# Access Compliance Report Public Rights-of-Way (Curb Ramps)

Main Street: DORRANCE\_DR Cross Street: SIENNA\_PKWY Location: W

ADA ID: RPRK211110124253 Ramp Type: Type 1 - Perpendicular Initial Pass/Fail: Fail Overall Compliance: No Severity Score: 2

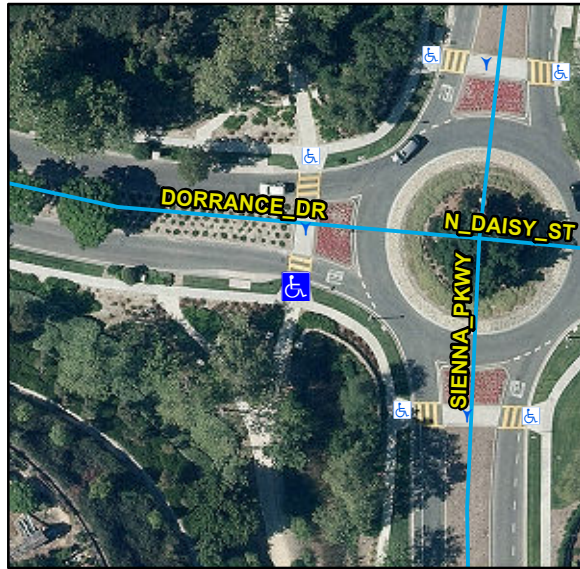
R204.3, R304.5.3, STD 1115

| Compliance | Description                           | Data | Compliance | Description                   | Data |
|------------|---------------------------------------|------|------------|-------------------------------|------|
| No         | Ramp Cross Slope (%)                  | 2.4  | N/A        | Flare Traversable LT          | N/A  |

Remove & Replace Entire Ramp.
